NIBLEY CITY COUNCIL MEETING AGENDA
Thursday, July 6, 2017 – 6:30 p.m.
Nibley City Hall 455 West 3200 South, Nibley, Utah

**Nibley City Council
Agenda Item Report for
July 6, 2017**

Description	Discussion and consideration of a final plat and development agreement for Apple Creek Subdivision (Formerly Tin Rope Subdivision), Phases 1 and 2, located at approximately 500 W and 3200 S
Department	Planning
Presenter	Stephen Nelson, City Planner
Applicant	Shaun Dustin
Findings	<p>The Plat received preliminary approval from the City Council on May 4, 2017</p> <p>The Plat received a recommendation of approval from the Planning Commission on June 21, 2017, with the following conditions:</p> <ol style="list-style-type: none"> 1) That the Conservation Land Acreage be noted on the plat. (This items has been fix) 2) That the Pedestrian ROW be shown as deeded to Nibley City. <p>Nibley City Staff has reviewed the construction drawing and sent a letter to the Developer with listed changes. The developer has replied to each concern listed by Nibley City staff. Nibley City Code states that construction drawings must be approved by the City Engineer.</p> <p>The Plat complies with Nibley Code and Desi

APPLE CREEK SUBDIVISION, PHASE 1

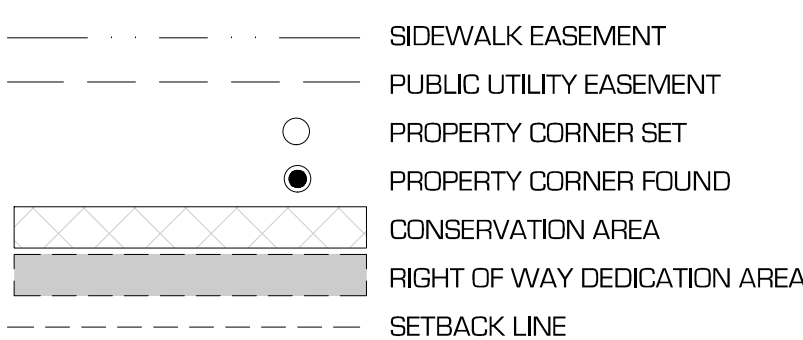
Nibley City staff has reviewed the plat and construction drawings and the developer is currently updating the plat and plan to correct two minor items to completely meet Nibley City Code and Design Standards. The plat was approved by the Planning Commission on June 21, 2017 with two conditions.

- 1) That the Conservation Land Acreage be noted on the plat.
- 2) That the Pedestrian ROW be shown as deeded to Nibley City.

Other than these two minor items, Nibley City staff does not have any concerns with the plat. The developer will be turning in updated construction drawing for the development that will need to be approved by Nibley City's engineer.
